**DOCUMENT 00 90 00
ADDENDUM**

ADDENDUM NO. [1] Date: August 14, 2019

**RE: LANESBORO PUBLIC SCHOOLS
 ADDITION AND REMODEL
 100 KIRKWOOD ST EAST
 LANESBORO, MN 55949
 HSR 18063**

**FROM: HSR Associates, Inc
 100 Milwaukee Street
 La Crosse, WI 54603
 (608) 784-1830**

E101P

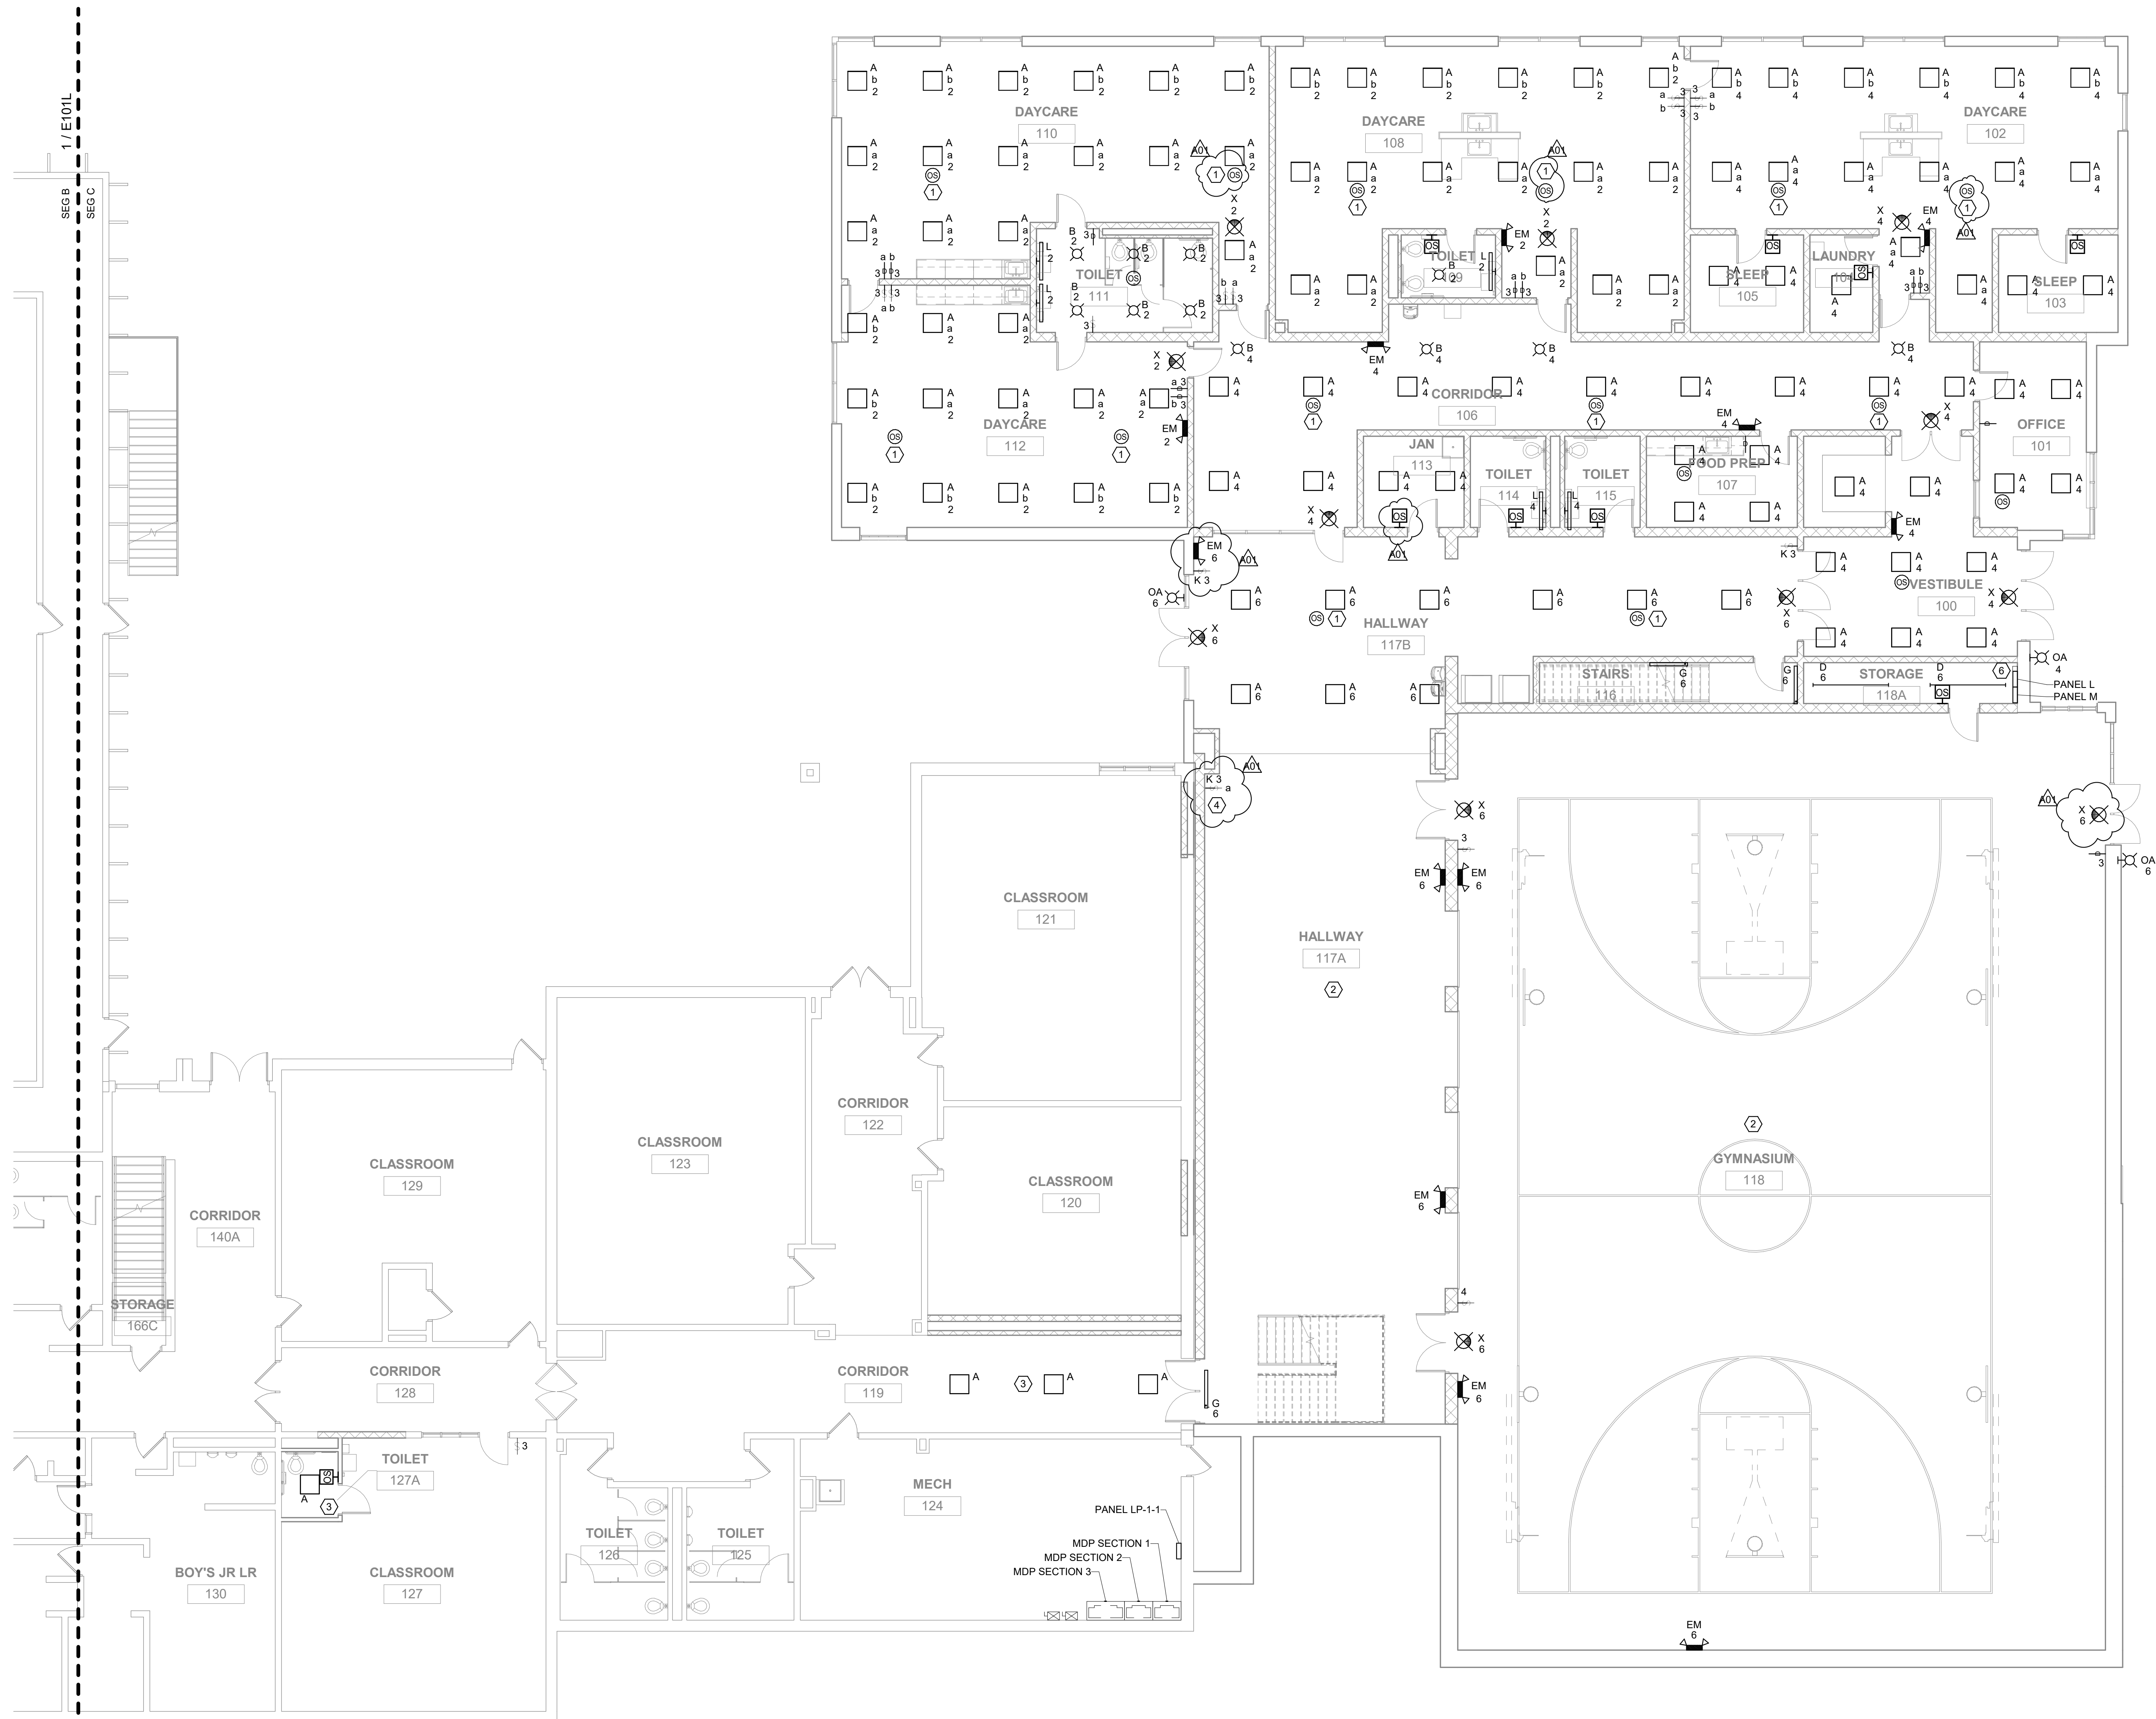
- b. Revise general lighting notes, as shown.
 - c. Add one (1) type EM fixture, as shown.
51. Sheet E101P LOWER LEVEL – SEGMENT B – POWER/SYSTEMS 30 x 42 attached hereto

- a. Revisions clouded on Drawing.
 - b. Revise receptacle locations in Receiving 161, as shown.
52. Sheet E102L LOWER LEVEL – SEGMENT C – LIGHTING 30 x 42 attached hereto

E102L

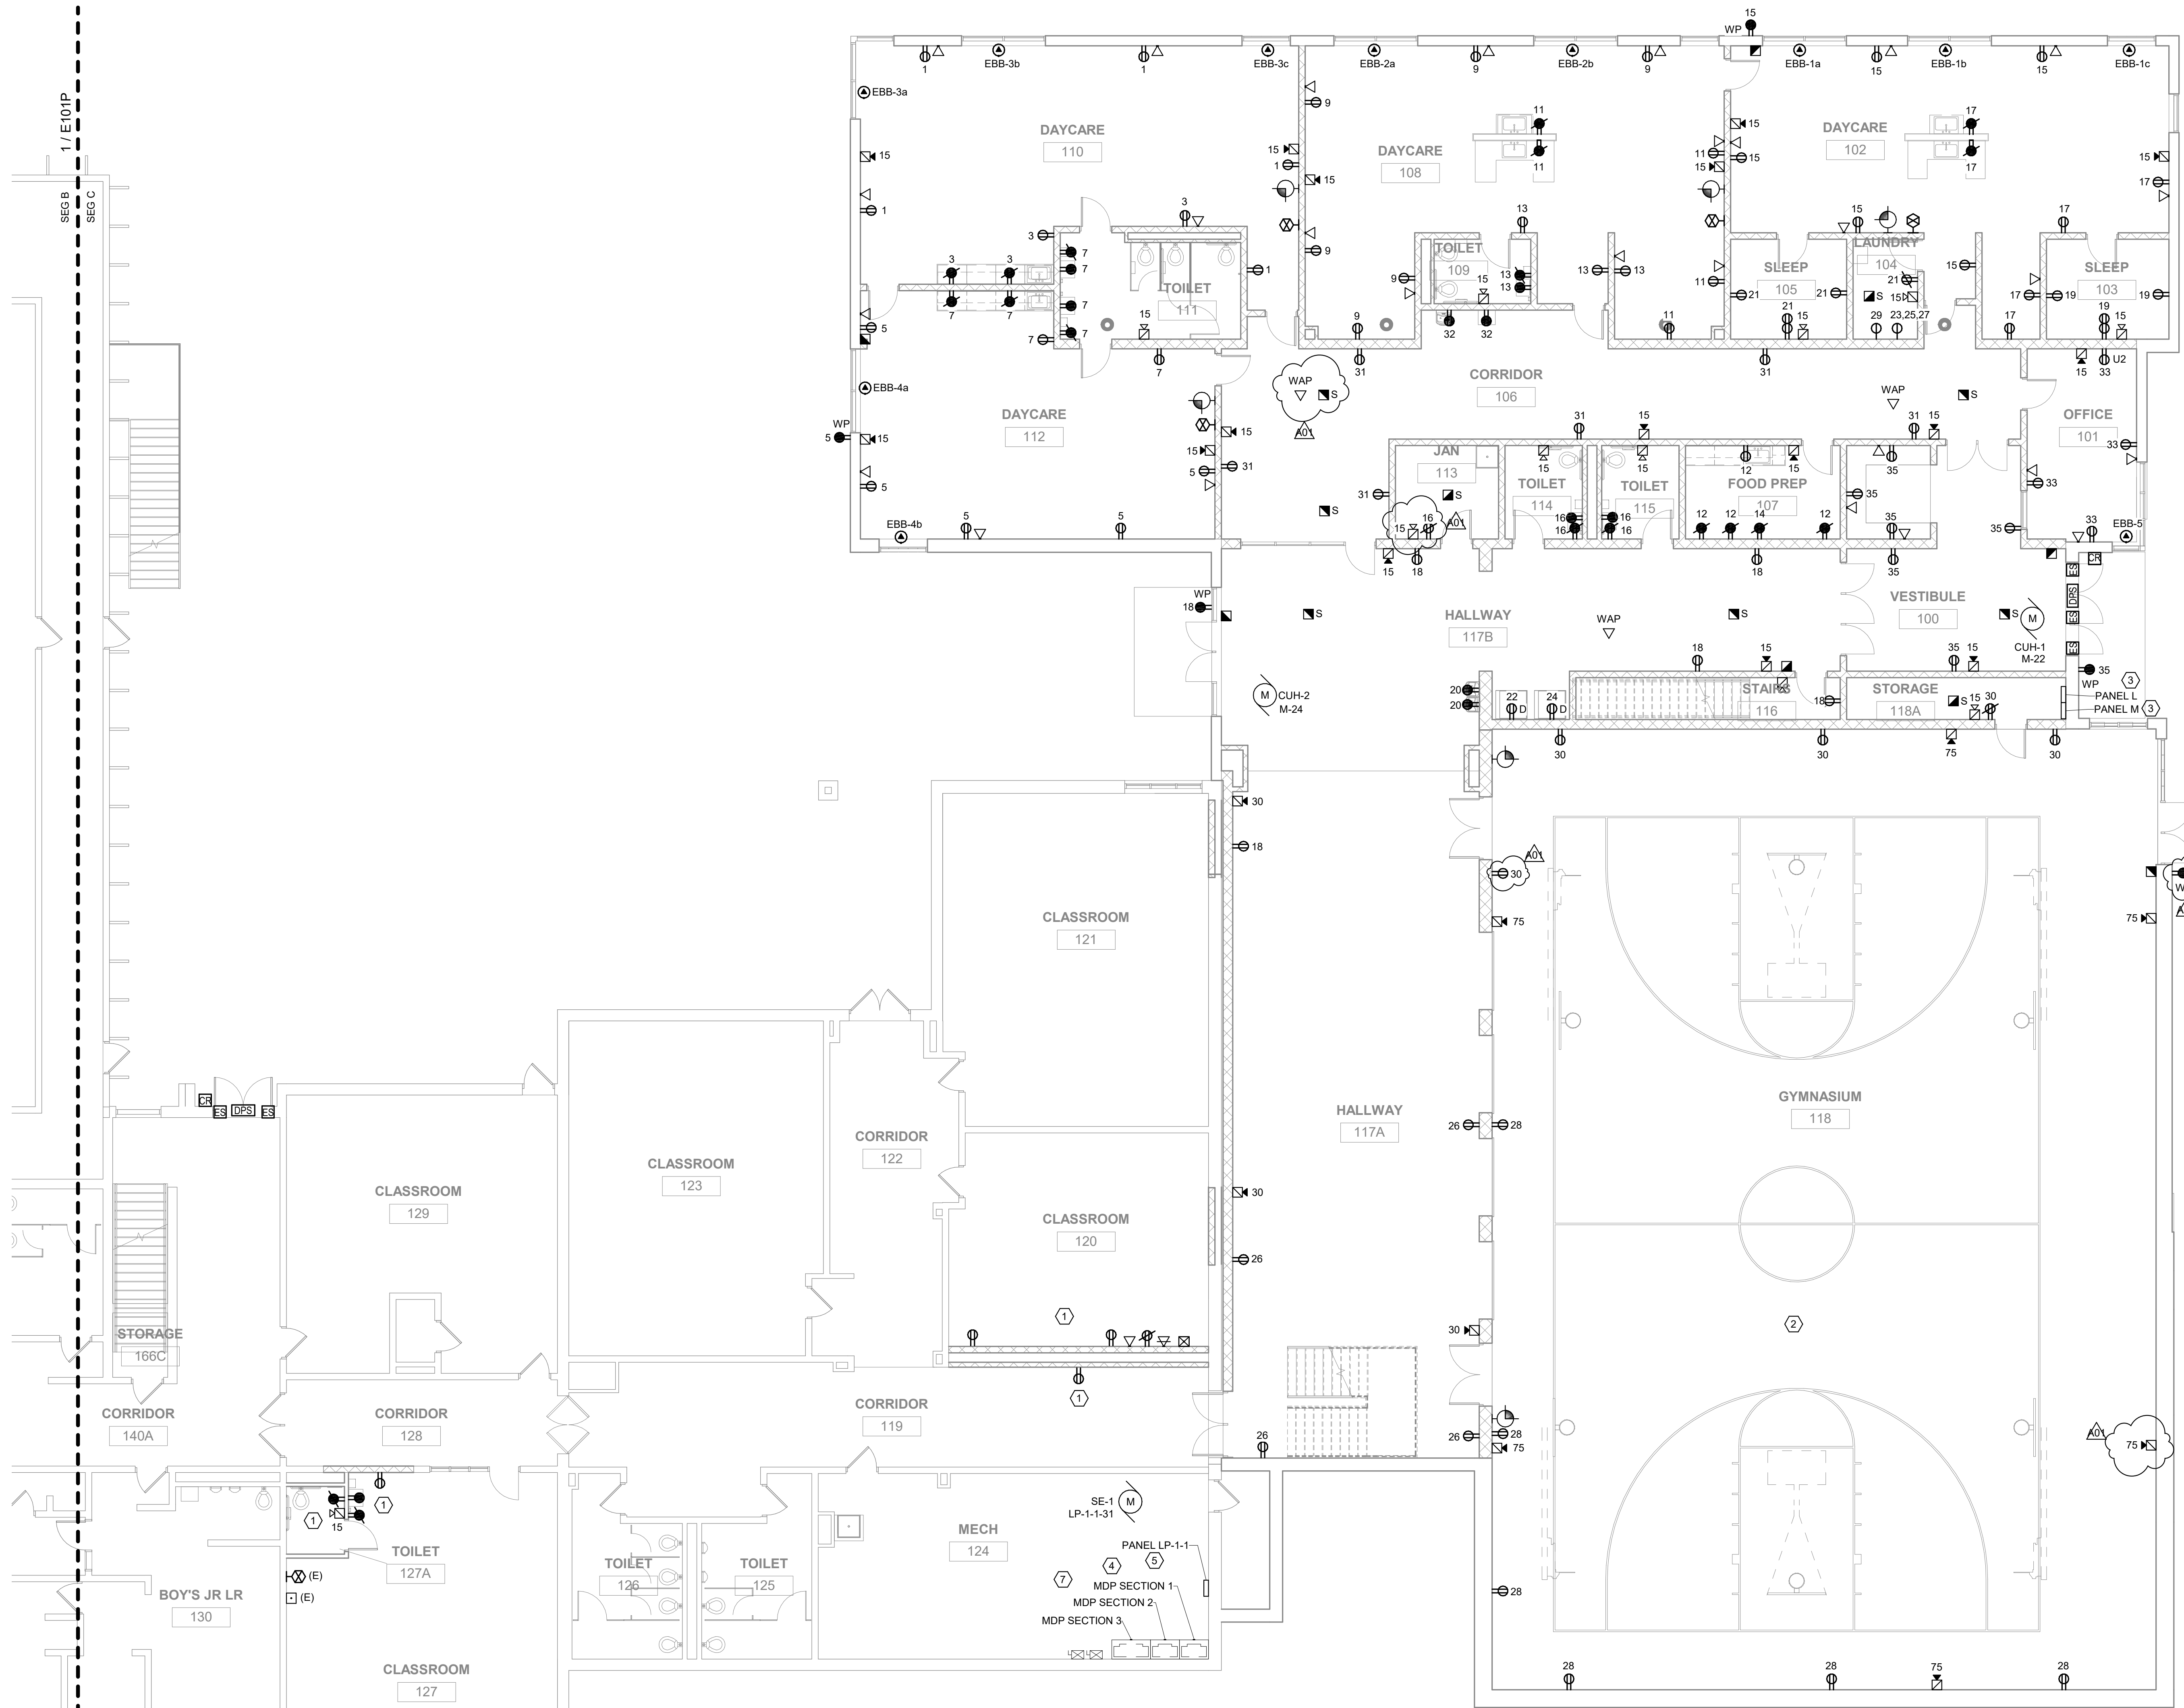
- a. Revisions clouded on Drawing.
 - b. Revise general lighting notes, as shown.
 - c. Revise occupancy sensor locations in rooms 102, 108, and 110, as shown.

- d. Revise switch and wall light fixture locations in Hallway 117B, as shown.
 - e. Add type X fixture in Gymnasium 118, as shown.
53. Sheet E102P LOWER LEVEL – SEGMENT C – POWER/SYSTEMS 30 x 42 attached hereto
